Project	IEEE 802.16 Broadband Wireless Access Working Group < http://ieee802.org/16 >	
Title	Bandwidth Request for Distributed Systems	
Date Submitted	2007-03-05	
Source(s)	Masato Okuda and Yuefeng Zhou Fujitsu	okuda@jp.fujitsu.com Yuefeng.Zhou@uk.fujitsu.com
	I-Kang Fu, Fang-Ching Ren, Chie-Ming Chou NCTU/ITRI 1001 Ta Hsueh Rd, Hsinchu, Taiwan, R.O.C.	IKFu@itri.org.tw
	Kenji Saito KDDI R&D Laboratories Inc.	Voice: +81 46 847 6347 saito@kddilabs.jp
	Shulan Feng, Yanling Lu, Ting Li, Liangliang Zhang Hisilicon Technologies Harbour Building, No.8, Dongbeiwang West Road, HaiDian District, Beijing, China	Voice: 86-10-82829010 Fax: 86-10-82829075 luyanling@hisilicon.com fengsl@huawei.com
Re:	IEEE802.16j-07/007r2: "Call for Technical Comments and Contributions regarding IEEE Project 802.16j"	
Abstract	This contribution proposes a distributed bandwidth request and allocation mechanism.	
Purpose	To propose text to describe a distributed bandwidth request and allocation mechanism

Bandwidth Request for Distributed Systems

[Figure X-1 Extended MAC Signaling Header Type II Format](#)

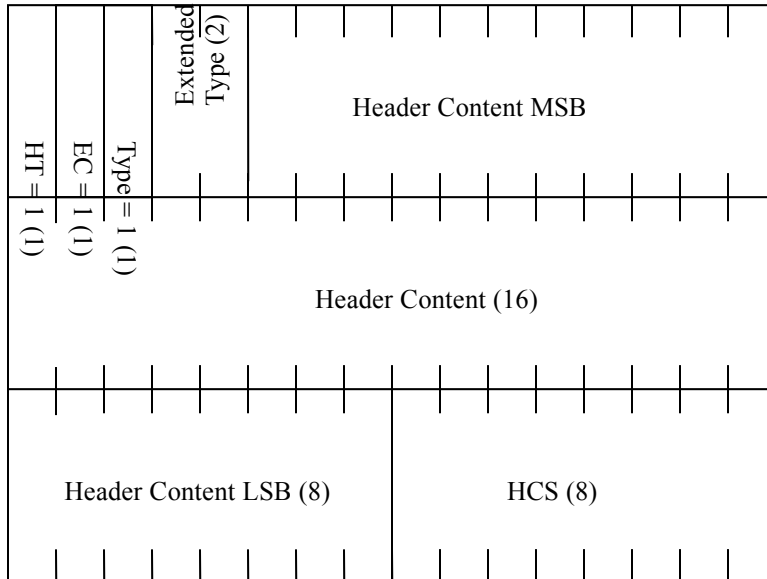
[Insert the following subclause at the end of 6.3.2.1.2.2:]

6.3.2.1.2.2.2 Extended MAC Signaling Header Type II

This type of MAC header is UL specific. There is no payload following the MAC header. The Extended MAC signaling header type II is illustrated in Figure X-1. Table X-1 describes the encoding of the 3-bit extended type field following the type field.

Figure X-1 Relay Bandwidth Request Header Format

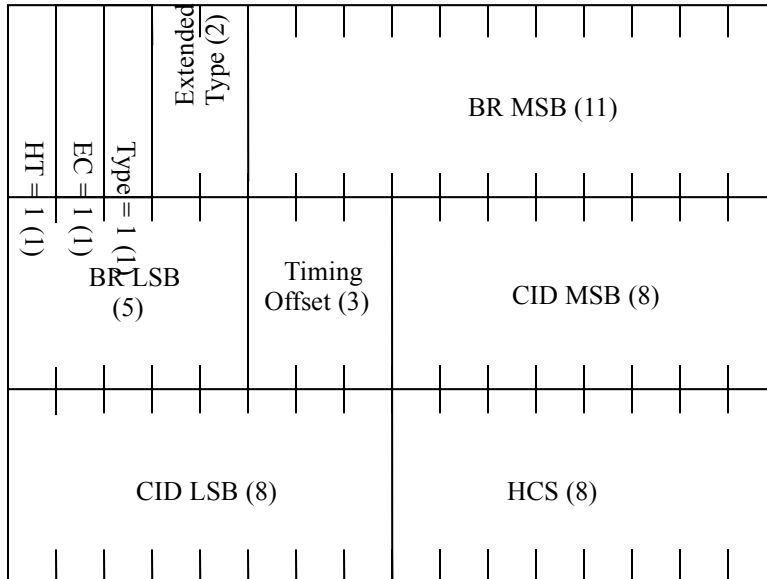
[6.3.2.1.2.2.1 Relay Bandwidth Request Header](#)

[The Relay Bandwidth Request header is sent by an RS to request bandwidth on the relay uplink to its upstream MR-BS or RS. In addition to the bandwidth request itself, the Relay Bandwidth Request Header includes timing offset information that indicates at what time this bandwidth needs to be allocated. The RS or MR-BS receiving the header shall wait a period of time equal to the timing offset before allocating bandwidth on the relay uplink to the downstream RS.](#)

Table X-2— Description of fields in Relay Bandwidth Request header

Name	Size	Description
<u>BR</u>	<u>16 bits</u>	<u>Bandwidth Request: The number of bytes of uplink bandwidth requested by the RS (unit of 4-Byte). The bandwidth request is for the CID. The request shall not include any PHY overhead.</u>
<u>Timing Offset</u>	<u>3 bits</u>	<u>Time (in units of a frame) the receiver shall wait before allocating bandwidth corresponding to this header.</u>
<u>CID</u>	<u>16 bits</u>	<u>The CID shall indicate the connection for which uplink bandwidth is requested.</u>
<u>HCS</u>	<u>8 bits</u>	<u>Header Check Sequence (same usage as HCS entry in Table 5).</u>
